**California American Water Company (Cal Am)
Monterey Peninsula Water Supply Project
Draft Environmental Impact Report**

Problems with the Evaluation of the CEMEX Model

Comparison of Measured Versus Model-Calculated Groundwater Elevations
 Transient Model Calibration (Water Years 1980-2011)

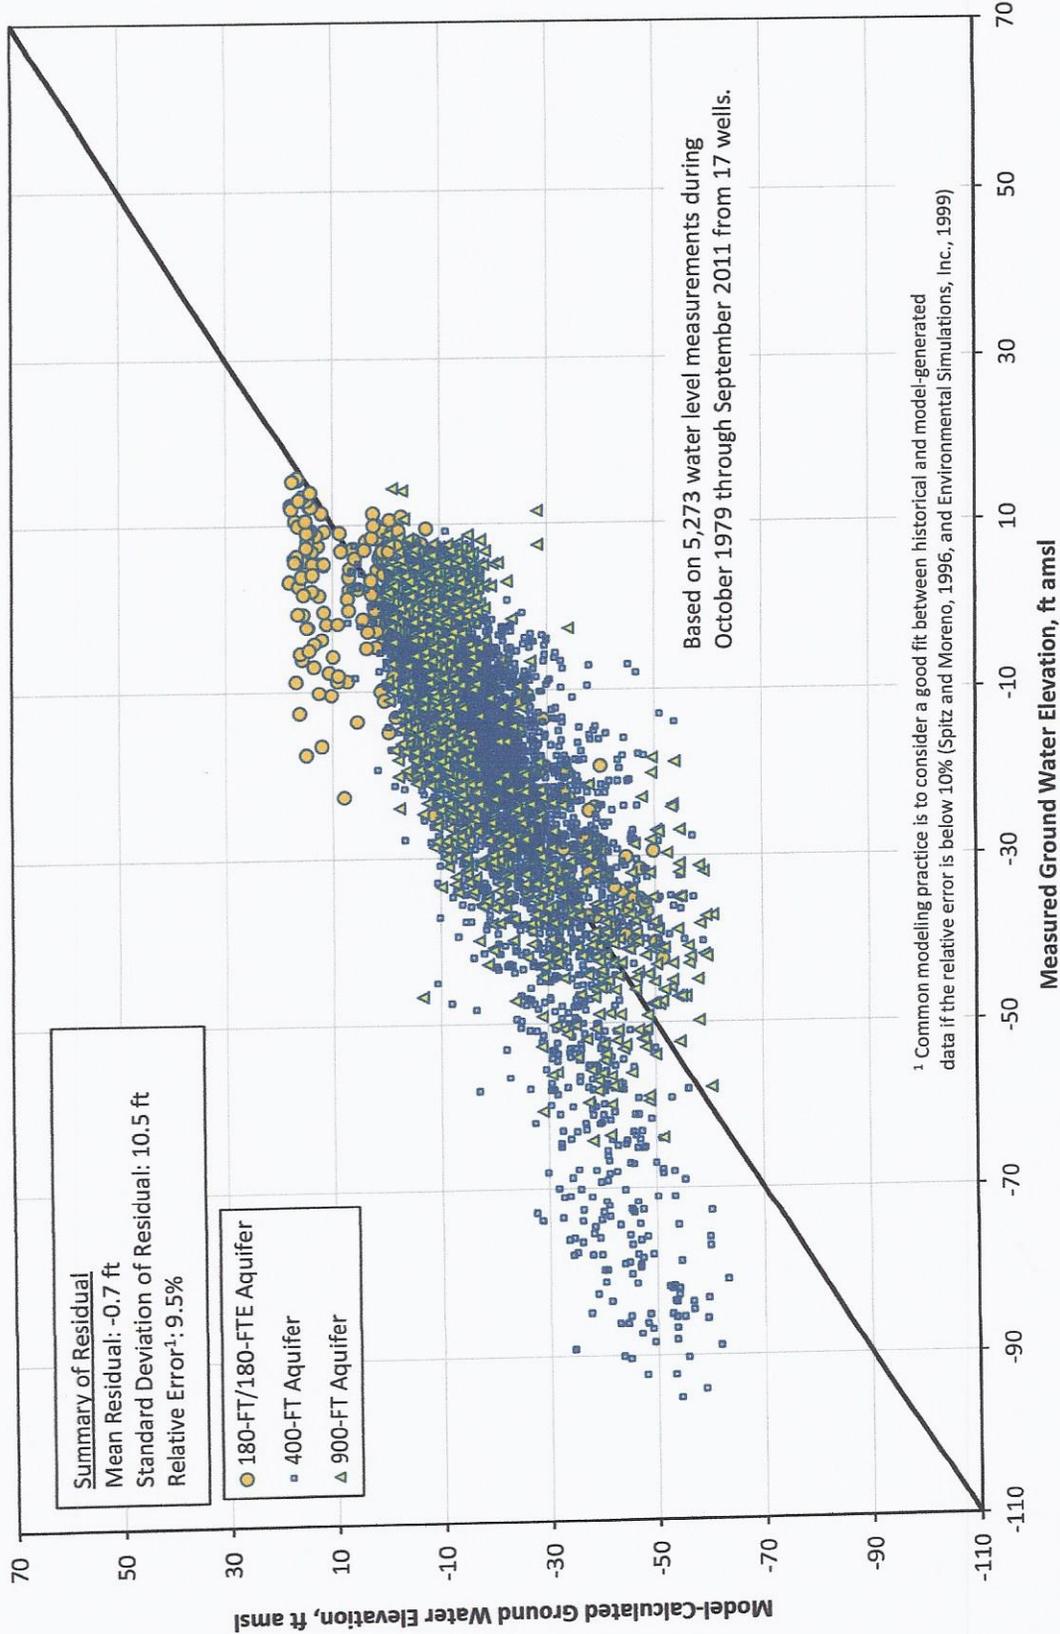
In investigating the DEIR evaluation of the CEMEX model, I have found some serious problems. Appendix E-2 shows a graph (attached) of observed and model-predicted measurements of groundwater elevations at different sites and times. To critique the evaluation thoroughly, I would need the Excel spread sheets showing the data and the calculations, which the DEIR does not supply.

For example, I cannot tell from the graph and its description in the text whether the residuals between observed and predicted measurements were computed by subtracting the first from the second (correct) or the second from the first (incorrect), which Appendix A to Appendix A of Appendix E-2 indicates is being done. Supporting the belief that the determination of residuals might be incorrect is the mean residual reported on the graph. It is -0.7 feet when it should be zero if the residuals had been determined correctly. As presented, the graph shows the estimation of predicted from observed measurements when a prediction line having equal predicted and observed measurements at the two extremes would be correct only if the estimation were in the opposite direction, unless the prediction were perfect (all the points falling on the line).

If you look at the graph, the difference between these two methods of residual computation for each data point is the identification of its residual as the horizontal distance (correct) or the vertical distance (incorrect) between the point and the diagonal line running through the dots from lower left to upper right.

Doing the calculation incorrectly could give a substantially better, but incorrect, evaluation of model fit. I would need the Excel spread sheet showing the data and the calculations to determine which way the residuals were determined and, if determined incorrectly, what the correct model evaluation might be.

Another serious problem with model evaluation is that the data points in the graph represent an area far more extensive than the CEMEX site to which the model is applied, as well as depths not accessed by the slant well there. The depths represented include not only the 180-foot aquifer, which the slant well accesses, but also the 400- and

900-foot aquifers, which the slant well does not access. In fact, the graph shows no data points representing the Dune Sand aquifer, even though it is accessed by the slant well. To provide a truly apt model evaluation, I would need the Excel spread sheet to evaluate the model separately for the 180-foot aquifer. Examination of the graph suggests that the fit for these data points (yellow-filled circles) may not be very good at all, many of the predicted elevations being uniformly much too high.

Since the slant well draws water only from the Dune Sand and 180-foot aquifers, a graph and residual calculations should be based on data from only these depths within the CEMEX area.

All this may seem overly technical, but the model fit is crucial to the DEIR since its conclusions are based on unconfirmed model predictions of future slant-well effects.

REPORTING REMEDIATION. The EIR should report the correlation coefficient between observed and predicted values for both the entire data set and for the data set restricted to the CEMEX area and the 180-foot aquifer. This statistic does not depend on the method of residual determination. One minus its square is the proportion of observed measurement variation that is not predicted, or is unaccounted for, by the model. This proportion is the statistical standard of model evaluation.

OPERATIONAL REMEDIATION. Since the model is unevaluated for one portion of its intake source region (Dune Sand aquifer) and is inadequately and likely erroneously evaluated for the other (180-foot aquifer) at the CEMEX site, reliance on the model to make predictions of the impact of slant-well pumping on groundwater elevations is out of the question for any envisioned scenario. Data collection over dozens of months of test-well pumping is necessary to evaluate the effects of the proposed project on groundwater elevations before a decision can responsibly be made to go forward with the project. Without such data collection, no EIR would be adequate and no CPCN could be justified.
